GROVE CITY, OHIO - CITY COUNCIL Agenda

November 4, 2024

ORDINANCE C-41-24

AN ORDINANCE TO ACCEPT THE PLAT OF FARMSTEAD, PHASE 5B

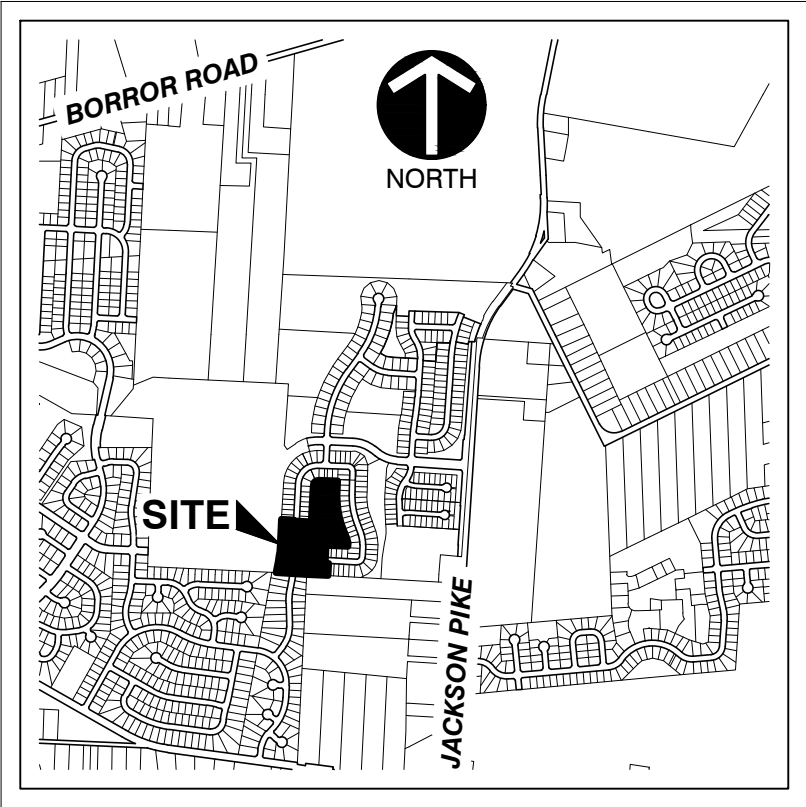
2. Label the drainage easement location starting at the rear of lot 247. **Label added**
3. Call out existing easement areas from phase 4 on lot 252. **Existing easement linestyle added to legend, 20' san esmt label on Lot 251. Access easement from previous phase is only in effect until the platting of this phase and cease to exist.**

4. Call out existing easement areas from phase 3 on lots 237 and 261 (Windcliff Drive east easements). **Existing easement linestyle added to legend. Access easement from previous phase is only in effect until the platting of this phase and cease to exist.**

5. Add language for access easements. Language from Note "F" on previous Phases 3 and 4 should be added. **Access note for the CBU boxes has been added to the dedication to be consistent with previous plats. The Note "F" from phases 3 and 4 do not apply to this phase as all roads are tying into existing streets.**

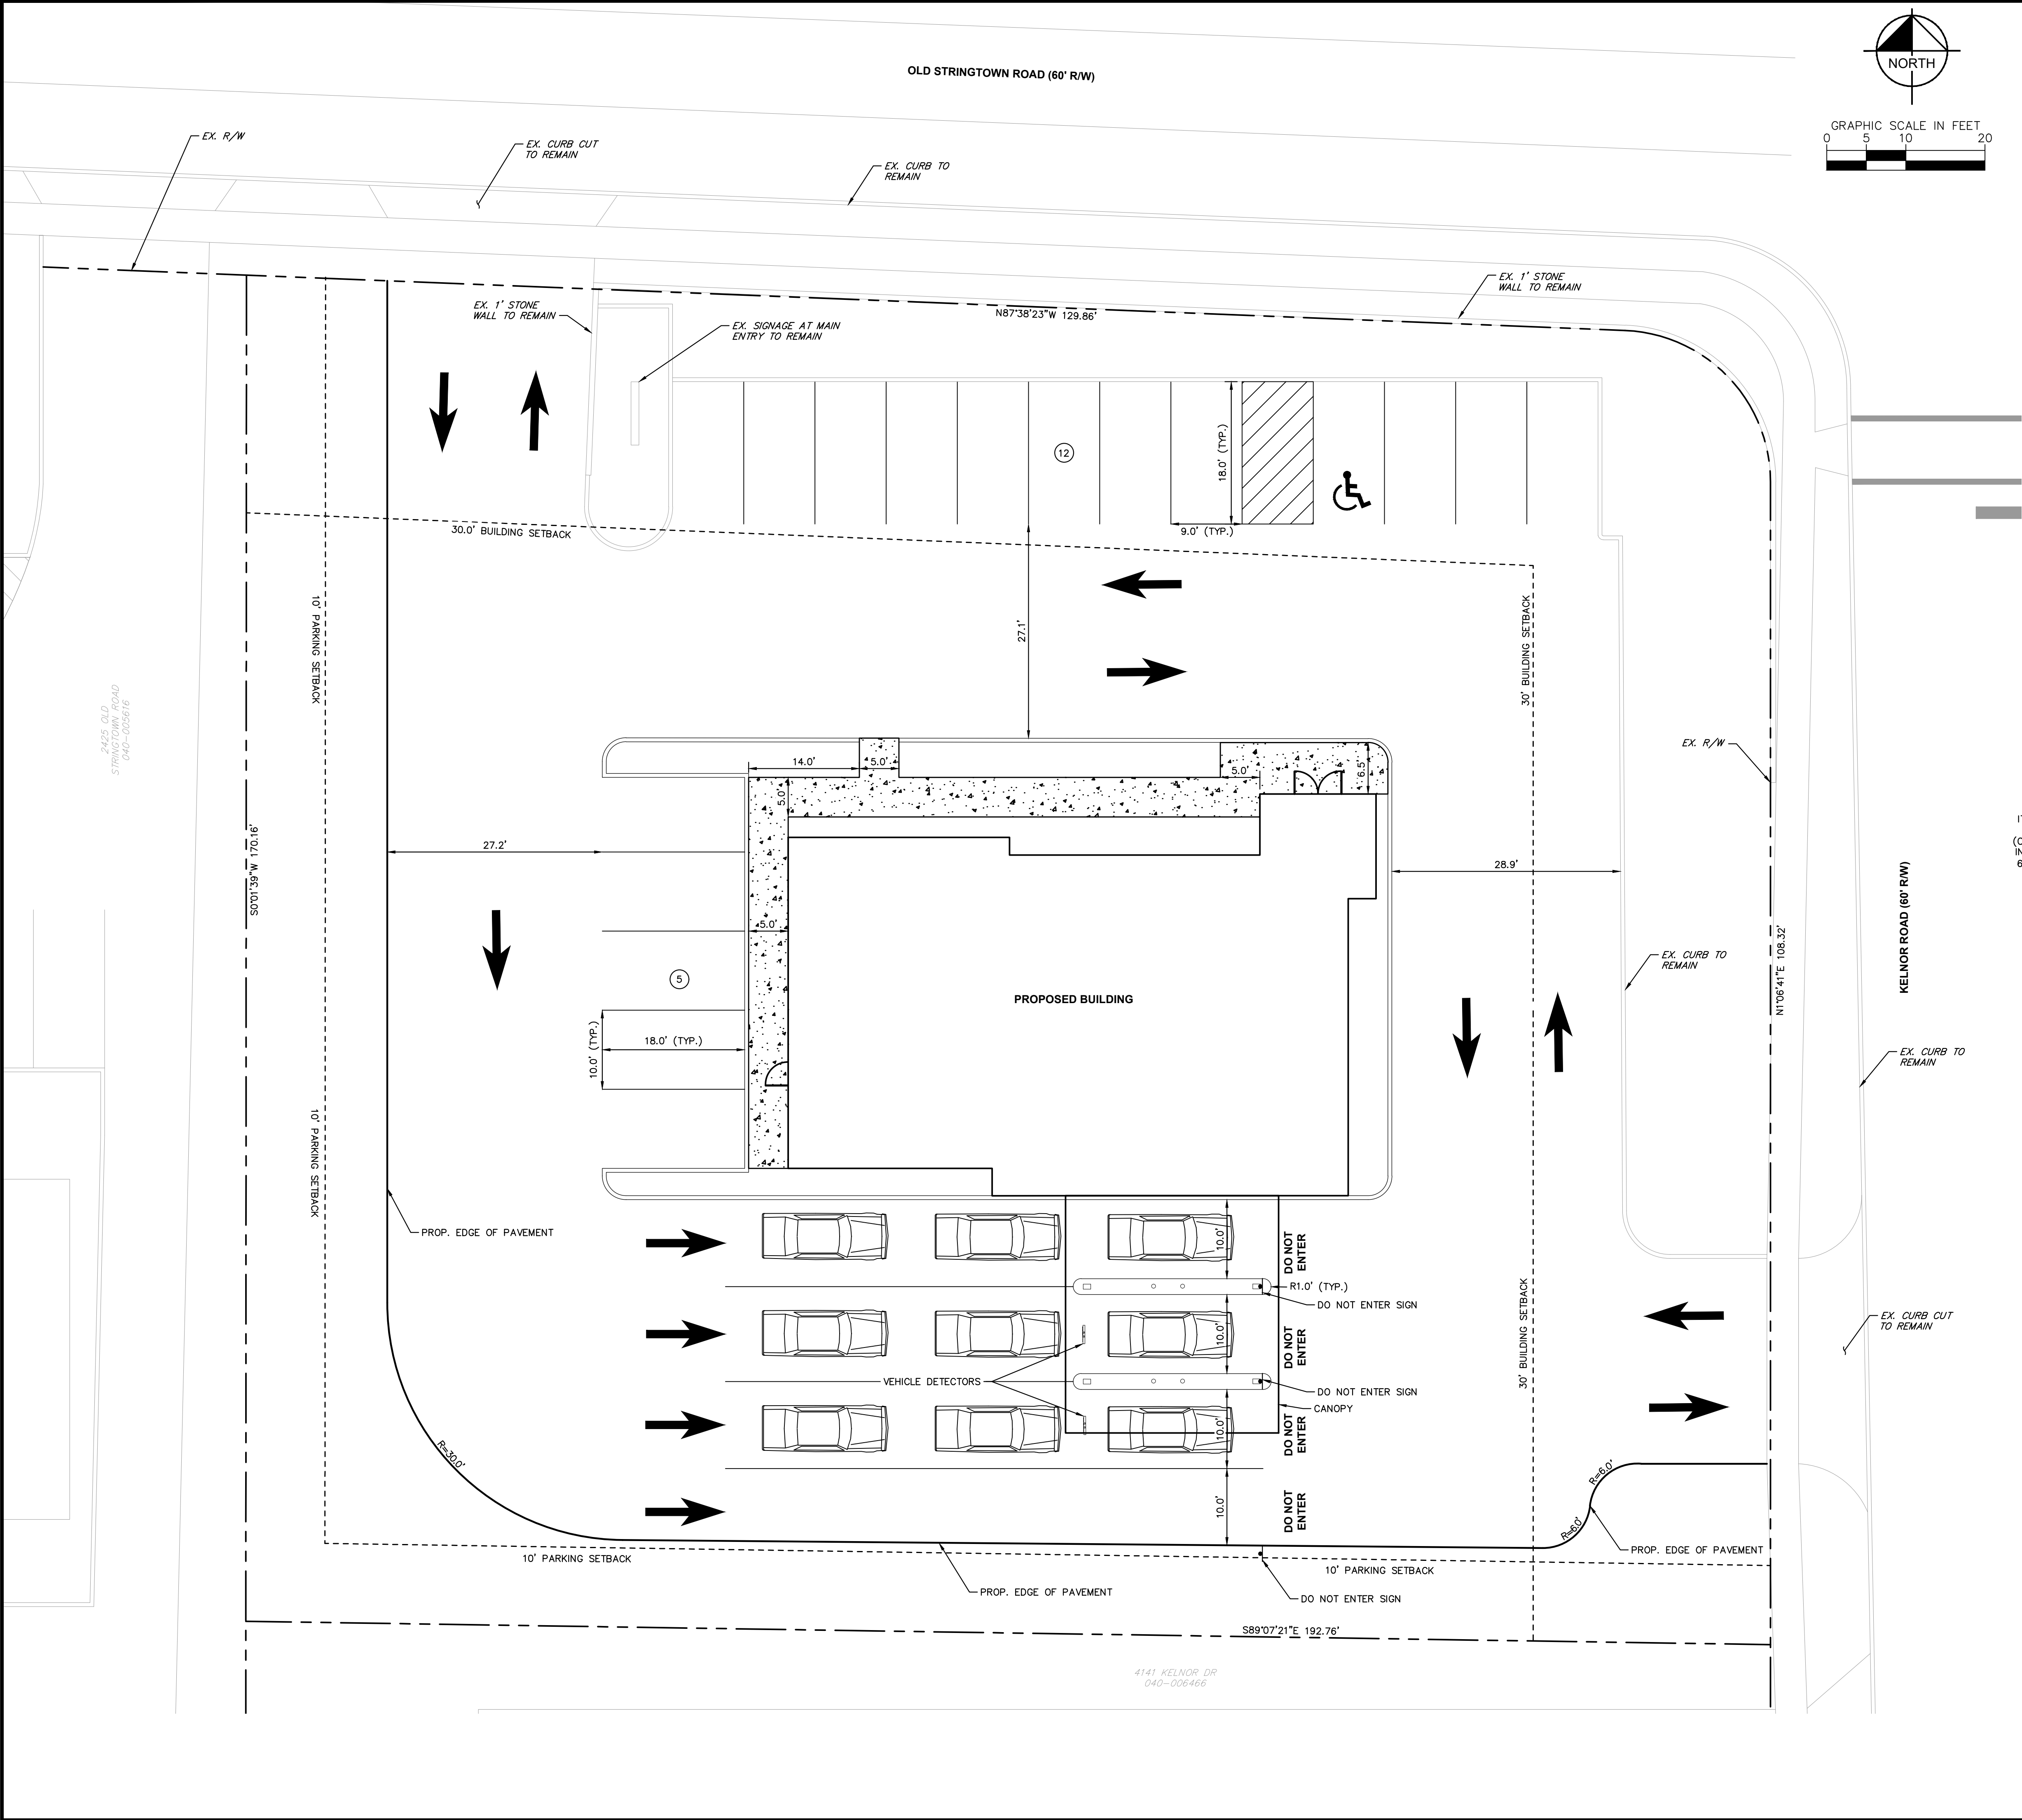
2. Please be advised that while the site plan is not approved and reviewed in detail until the Development Plan application, the drive-thru layout does not meet the 10-foot parking and drive aisle setback required by code. Staff recommend reducing the number of lanes to two (2) to meet the required 10-foot setback.

3. Stacking information needs to be provided to show the number of vehicles able to stack in the drive-thru lanes, demonstrating that the proposed use would not impact site circulation.

4. "Do Not Enter" pavement markings and signage should be installed at the drive-thru exit to clarify one-way circulation.

The building and ATM, teller and escape lanes have been adjusted to ensure site perimeter setback requirements are met on the revised site plan. (See Kimley-Horn Site Plan - Special Use Permit updated 9-25-24.)

Please see Kimley Horn's updated stacking detail on the revised site plan. (See Kimley-Horn Site Plan - Special Use Permit updated 9-25-24.)

Please find Kimley Horn's updated notes/locations indicating "Do not Enter" signage as indicated on the revised site plan. (See Kimley-Horn Site Plan - Special Use Permit updated 9-25-24.)
